Amendment C109 Manningham Planning Scheme - Land Subject to Inundation Overlay and Special Building Overlay - Consideration of Submissions and Request for a Panel Hearing

File Number:	IN17/63
Responsible Director:	Director Planning and Environment
Attachments:	<ol style="list-style-type: none">1 Flood Mapping Catchments, 20152 Development of the Special Building Overlay Technical Report, Cardno September 20153 Planning Scheme Amendment C109 Amendment Documentation4 Consultation Report and Summary of Issues in Submissions5 Officer Response to Issues Raised in Submissions6 Template and Criteria7 Cardno Report February 20178 Peer Review, Water Technology July 20169 Summary of Submissions, Officer response and Recommendation10 Table of Recommended Changes to Submitter Properties11 Value Impact Assessment, Charter Keck Cramer, November 201612 Table of Recommended Changes to Non-submitter Properties

The purpose of this report is to consider all submissions received to Amendment C109 to the Manningham Planning Scheme.

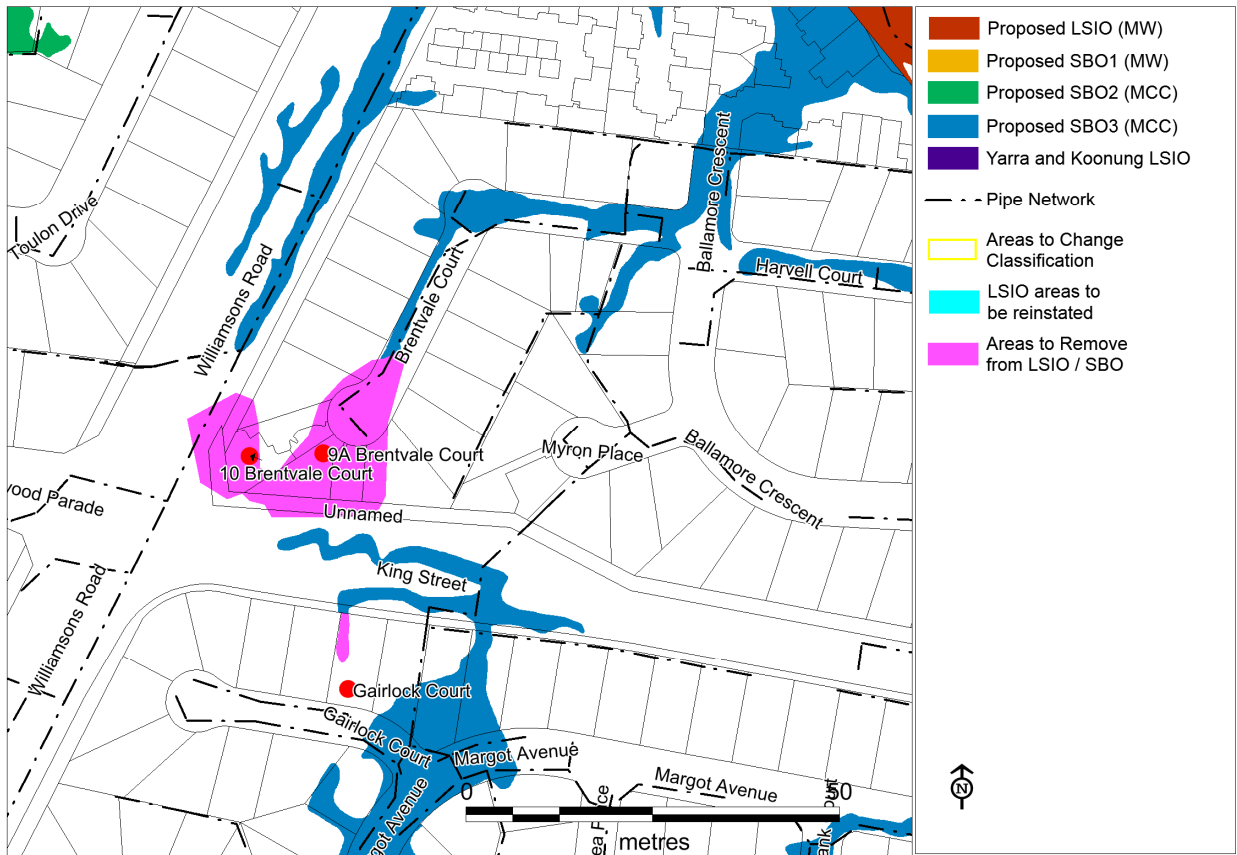
3 & 4A Myron Place – there appears to be SBO missing.	There is sufficient pipe capacity in this area, particularly as water is retarded upstream at Gairlock Court.

Outcome: Remove SBO2 from properties 11 Gairlock Court, 10 & 9A Brentvale Court

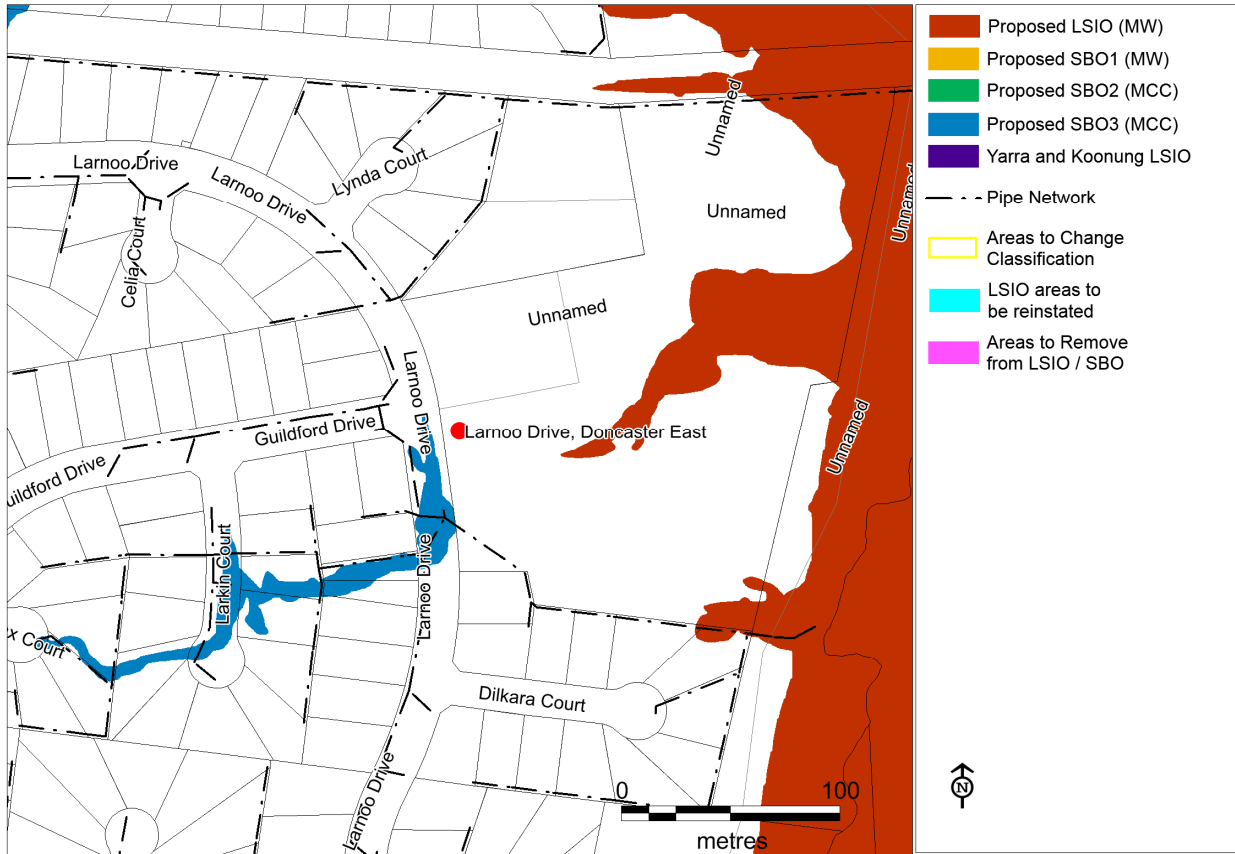
The submitter queries why the flow path is shown as discontinuous. The flow path is discontinuous as there is a pipe diameter change. The smaller pipes converge into a 600 mm pipe immediately upstream of where the 'discontinuity' is reported.

Outcome: No Change Proposed

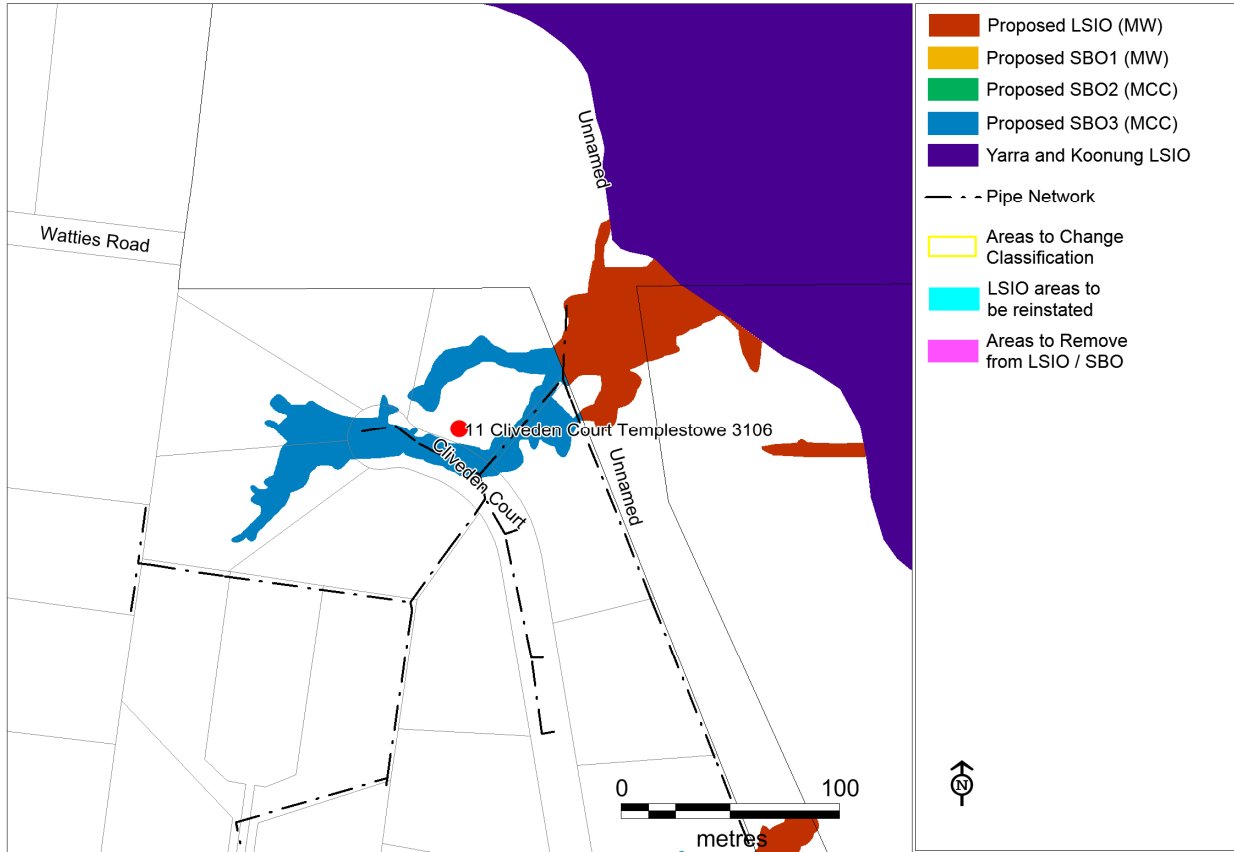
As a result of this assessment for 11 Cliveden Court it is recommended that the proposed SBO3 remains on the property.

Outcome: No Change Proposed

6.13.2.1 *Dispute Item 1*

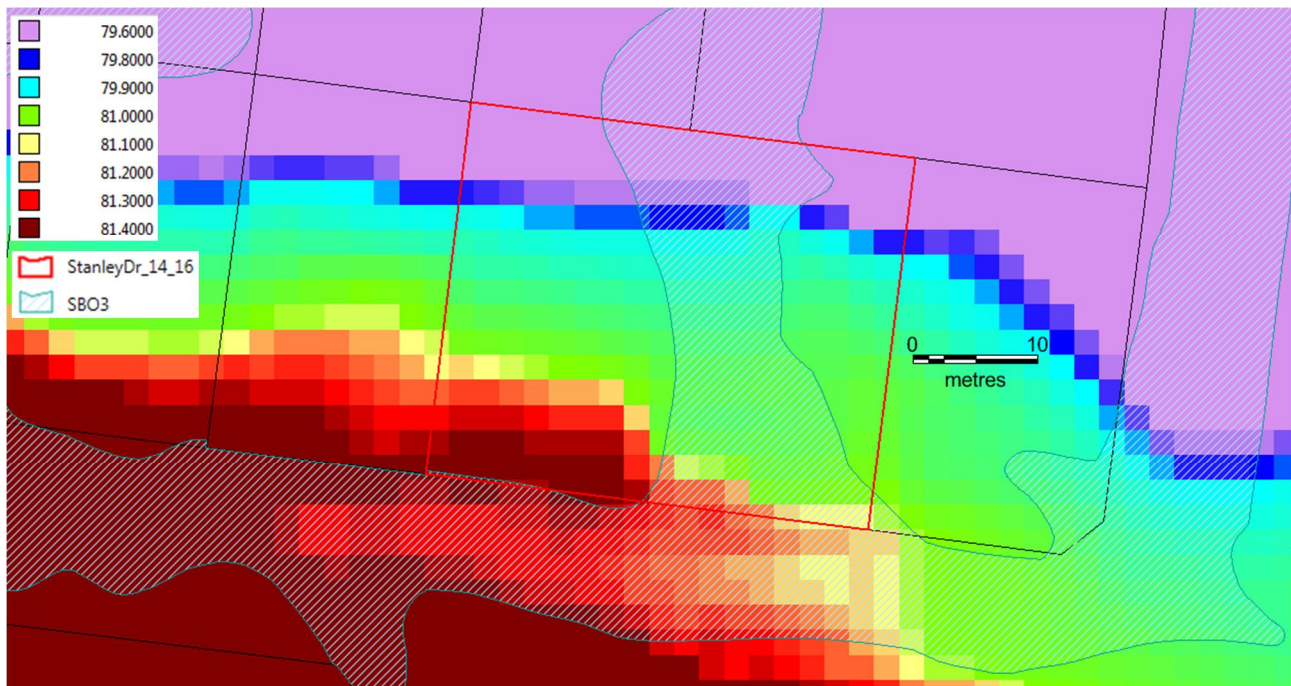
Summary of dispute: The road is located lower than the footpath crest and water would preferentially flow down the road toward Viscount Drive.

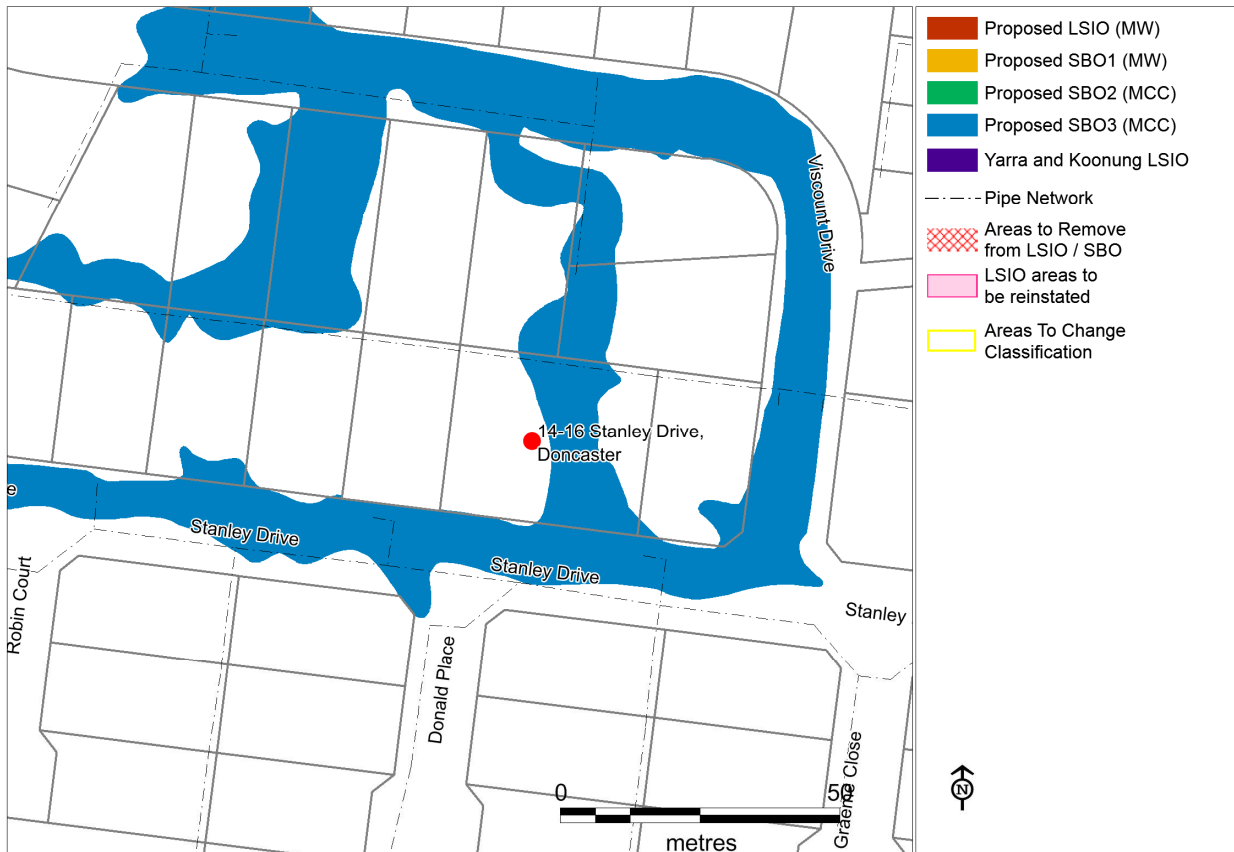
Summary of dispute: The upstream contributing catchment is not sufficient to generate flows that would overtop this footpath threshold.

The volume of water is not excessive, but the intensity of rainfall is high enough to both fill the underground drainage pipes and overtop the footpath. As mentioned, the flows that overtop the footpath are only small but are enough to accumulate to a noteworthy depth of flooding due to the significant drop-off in surface elevation on the property side of the footpath.

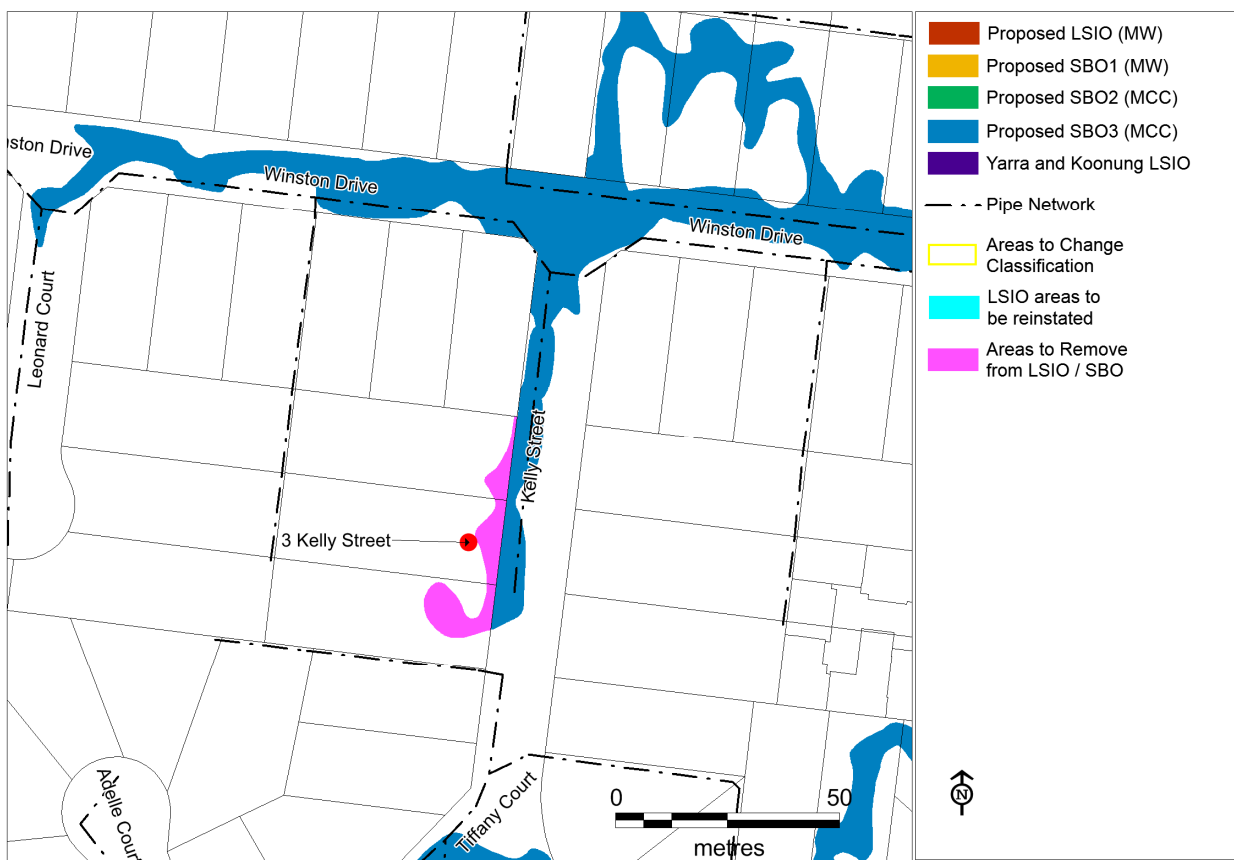
A detailed study of the area was undertaken and it was found that the modelled surface was not representative of actual conditions at the resolution analysed. The resolution of the model has not adequately picked up the gutter as well as large brick fences that would block water from flowing into the property at the depths recorded in the modelling results. Upon inspection of the street, it is more likely that flood waters will remain within the roadway. Therefore, it is recommended that 1, 3 and 5 Kelly Street be removed from the SBO3.

Proposed Resolution for Property

Figure 2- Bulleen North Drain – example isolated areas of SBO3

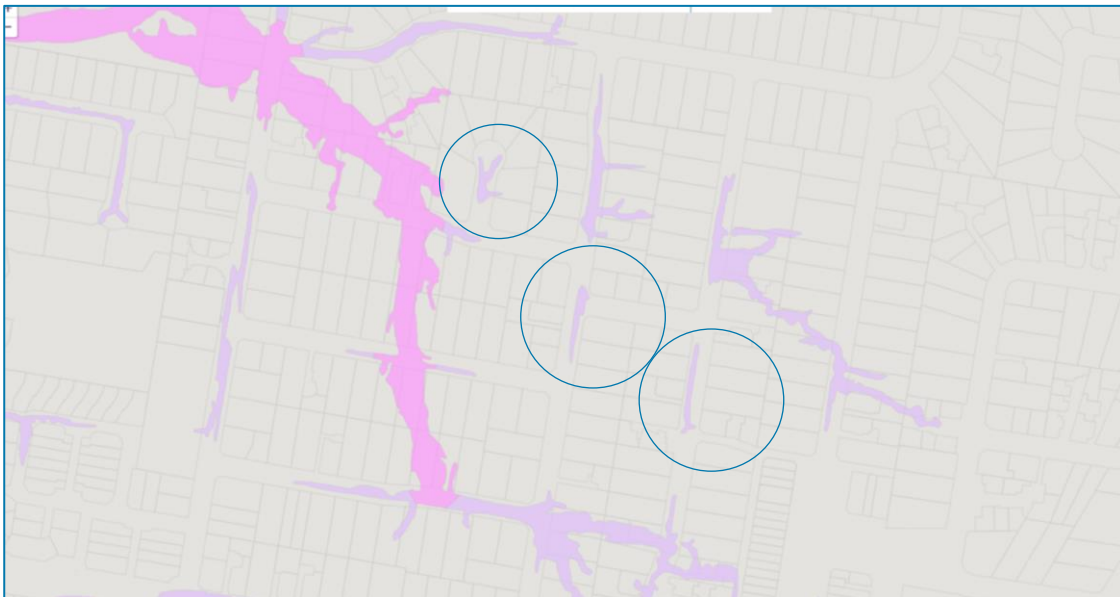
One issue that I have observed in the mapping outputs is the existence of multiple areas of isolated flood extent, particularly in the SBO3 layer. Figure 2 below shows an example section of the online flood overlay map from the Council website. This illustrates there are small sections of SBO3 that are mostly, if not entirely, within the road reserve. It could be argued that these areas do not serve a strong purpose compared to other areas connected to the main flow paths or ponding areas. In many of these places depths are very shallow, no property is directly affected and planning controls or conditions are unlikely to be required. It appears that these areas of shallow depth within the road reserve are unlikely to restrict access or impose any safety risk for evacuation or emergency service access. In my experience this information can be very useful to council officers for understanding nuisance flooding and planning maintenance or mitigation works. However, it is not necessary to include all flood information into an overlay and some manual thinning or cleaning up of the SBO3 layer may be beneficial. Such flood mapping extents may cause unnecessary anxiety within the community and additional work for council planning officers.
